AUBURN HILLS ADDITION

**SUBDIVISION COMMITTEE
METROPOLITAN AREA PLANNING COMMISSION**

STAFF REPORT

CASE NUMBER: S/D 94-12 AUBURN HILLS [Previously CANNONBALL ADDITION (135th & Maple)]

VICINITY MAP:

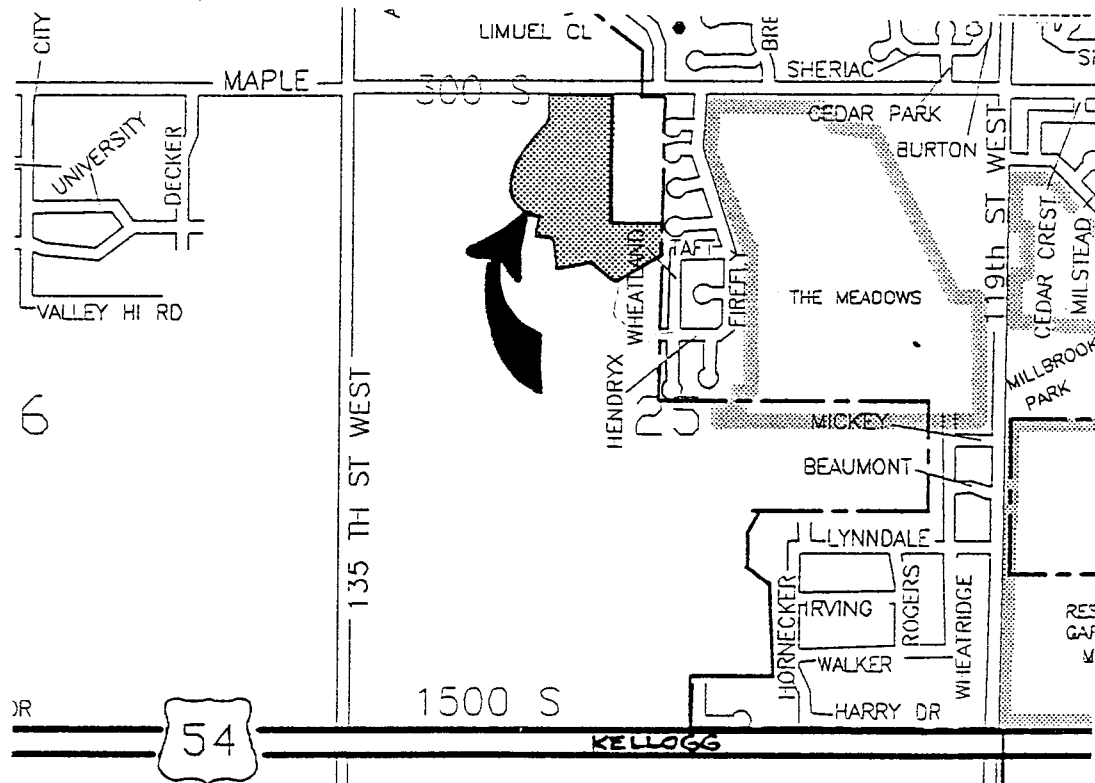
- A. Prior to this plat being scheduled for City Council review, this site will need to be annexed to the City. Annexation is required in order to plat the size of lots being indicated by this plat. Although this portion of the quarter section does abut the present City Limits at its eastern most property line and can therefore be annexed by itself, it is recommended that the applicant(s) submit an annexation request for the entire quarter section.

- B. The applicant shall guarantee the extension of sanitary sewer to serve the lots being platted.
- C. The applicant shall guarantee the extension of City water to serve the lots being platted.

- D. The applicant shall guarantee any drainage improvements required by the platting of this property.
- E. The applicant shall guarantee construction of the storm sewers required by this plat.

- F. The applicant shall guarantee the paving of the proposed interior streets.
- G. The above paving petition shall also provide for sidewalks along one side of Auburn Hills. Based upon the overall sketch plat, some portions of sidewalks could be considered, as an alternative, being located in an open space/drainage corridor that crosses this site from west to east. At this time the applicant shall guarantee sidewalk adjacent to the street up to the vicinity of Lot 1, Block B. Based upon the applicant's overall plans for this area and indicated agreement, an equivalent segment of sidewalk may be placed in the open space reserve to be platted south of this site rather than along the remaining portion of Auburn Hills.

- H. In terms of the overall development planned for this quarter section, 135th Street West can be expected to be a major means of access to both the residential development and if a 16 acre area of "LC" zoning is obtained, even more so for these uses. As an unpaved street consequently, paving is going to be needed for this street south from Maple. This plat and all subsequent plats in this quarter section need to therefore guarantee their participation in future paving of 135th Street that is proportionate to the traffic impact created by this development.

Therefore, before submitting the final plat tracing for City Council review, the applicant shall meet with Planning and City Engineering in order to determine an appropriate guarantee from this site for the paving of 135th Street West.

- I. The overall plan for this site is indicating that approximately 370 single family lots will be

developed. Only one entrance, as shown on this plat, and two off of 135th Street West will be used for access. These improvements need to be considered not only in light of the anticipated number of residential lots but also the potential "LC" zoning being proposed. As indicated by Traffic Engineering, a guarantee shall be provided for left-turn improvements in Maple to serve this site's entrance at Maple.

- J. Provisions shall be made for ownership and maintenance of the proposed reserves. The applicant shall either form a lot owners' association prior to recording the plat or shall submit a covenant stating when the association will be formed, when the reserves will be deeded to the association and who is to own and maintain the reserves prior to the association taking over those responsibilities. This covenant shall provide that the homeowners' association will maintain the open space area or "parking strip" located between this plat's north line and the paved surface of Maple.

- K. The applicant shall submit a covenant which provides for four (4) off-street parking spaces per dwelling unit on each lot which abuts a 58-foot street. The covenant shall inventory the affected lots by lot and block number and shall state that the covenant runs with the land and is binding on future owners and assigns.

- L. The representative from the City's Fire Department needs to comment upon the acceptability of the street names now being shown on this plat.
- M. The platting binder presently indicates that this site is owned by another party or not as is indicated on this final plat. Before the plat will be released for recording, proof of ownership shall be shown for the party indicated on the final plat.

- R. The representative from City Engineering should be prepared to comment on the status of the applicant's drainage plan. Further, the applicant needs to determine with Engineering the nature or extent of any detailed drainage study needed for the overall quarter section in which this plat is located.

- S. Perimeter closure computations shall be submitted with the final plat tracing. Section 5-101(c).
- T. Recording of the plat within 30 days after approval by the City Council.

VICINITY MAP:

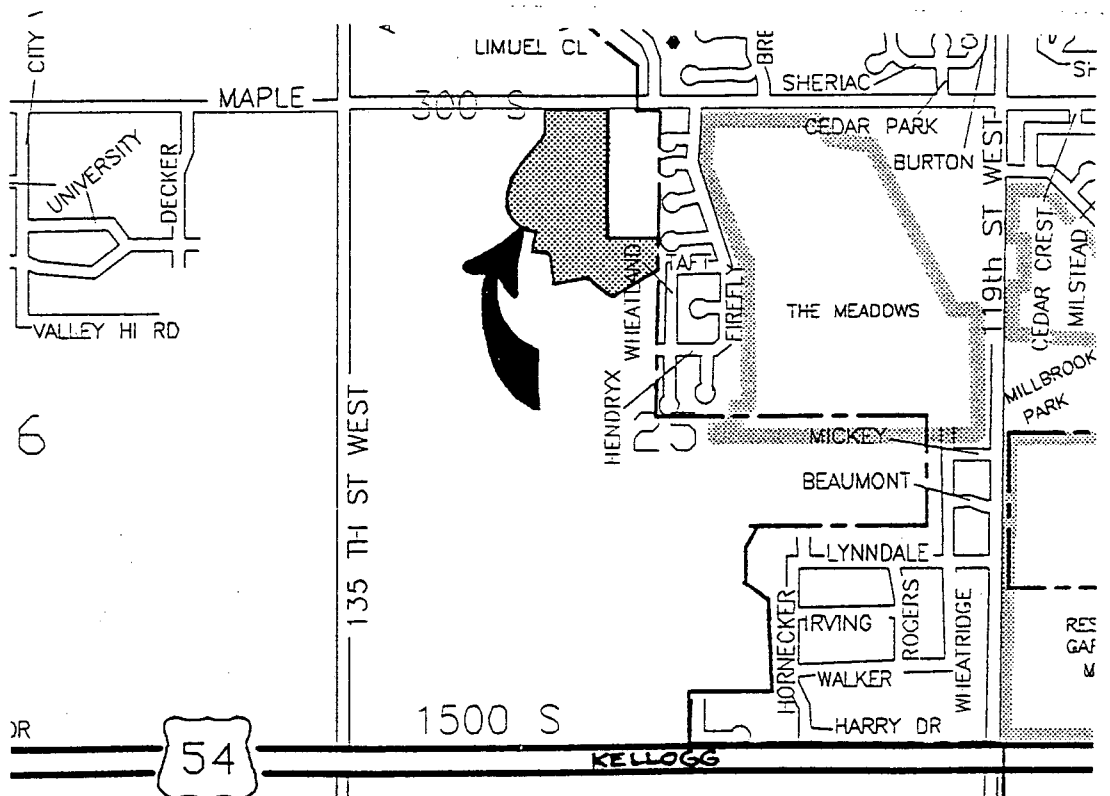
- A. Prior to this plat being scheduled for City Council review, this site will need to be annexed to the City. Annexation is required in order to plat the size of lots being indicated by this plat. Although this portion of the quarter section does abut the present City Limits at its eastern most property line and can therefore be annexed by itself, it is recommended that the applicant(s) submit an annexation request for the entire quarter section.

- B. The applicant shall guarantee the extension of sanitary sewer to serve the lots being platted.
- C. The applicant shall guarantee the extension of City water to serve the lots being platted.

- D. The applicant shall guarantee any drainage improvements required by the platting of this property.
- E. The applicant shall guarantee construction of the storm sewers required by this plat.

- F. The applicant shall guarantee the paving of the proposed interior streets.
- G. The above paving petition shall also provide for sidewalks along one side of Cannonball. Based upon the overall sketch plat, some portions of sidewalks could be considered, as an alternative, being located in an open space/drainage corridor that crosses this site from west to east. However, it is not clear from this portion of the overall site as to precisely where or how this corridor will actually be platted. No alternative can therefore be considered at this time.

- H. In terms of the overall development planned for this quarter section, 135th Street West can be expected to be a major means of access to both the residential development and if the 16 acres of "LC" zoning is obtained even more so for these uses. As an unpaved street consequently, paving is going to be needed for this street south from Maple. This plat and all subsequent plats in this quarter section need to therefore guarantee their participation in future paving of 135th Street that is proportionate to the traffic impact created by this development.

City Engineering needs to indicate if or what forms of petitions or agreements may be required at this time in order to have this site participate in the paving of 135th Street West.
- I. The overall plan for this site is indicating that approximately 370 single family lots will be developed. Only one entrance, as shown on this plat, and two off of 135th Street West will

be used for access. Traffic Engineering needs to indicate if this situation requires this site to guarantee traffic improvements such as accel, decel, left turn lanes for the entrance at Maple. These improvements need to be considered not only in light of the anticipated number of residential lots but also the potential "LC" zoning being proposed.

- J. Based upon the Comprehensive Plan for this area, an open space-recreational corridor is planned along Maple to provide access to a planned park east of this site. To provide for this corridor the final plat shall dedicate 20 to 25 additional feet of right-of-way along Maple.
- K. On the final plat, complete access control shall be shown on the face of the plat and dedicated in the plat's text to Maple Street from the lots and Reserves adjacent to this street.

In regard to Cannonball, as an internal, residential street, there is no need to plat access control and such access control may be deleted from the final plat.

- L. The final plat shall indicate an appropriate name for this plat. Apparently, the applicant has indicated the intention to use the name "Cannonball".

- M. The final plat shall state in the plat's text the purposes of the proposed reserves as well as who is to own and maintain the reserves.
- N. Provisions shall be made for ownership and maintenance of the proposed reserves. The applicant shall either form a lot owners' association prior to recording the plat or shall submit a covenant stating when the association will be formed, when the reserves will be deeded to the association and who is to own and maintain the reserves prior to the association taking over those responsibilities. This covenant shall provide that the homeowners' association will maintain the open space area or "parking strip" located between this plat's north line and the paved surface of Maple.

- P. The Fire Department needs to comment upon the acceptability of this plat's street names. Cannonball does not apparently line up precisely with existing names in this area and would appear to be an acceptable new name. However, Maple in some parts of the County may still be called by this name.

- Q. Requirements for a final plat (see pages 5-5 through 5-10, Part 4, Article 5 of the MAPC Subdivision Regulations).
- R. Prior to or at the time of submitting the final plat, the applicant shall submit a drainage plan to City Engineering for review and approval.

- V. The representatives from the utility companies should be prepared to comment on the need for utility easements to be platted on this property.
- W. The representative from City Engineering should be prepared to comment on the status of the applicant's drainage concept.
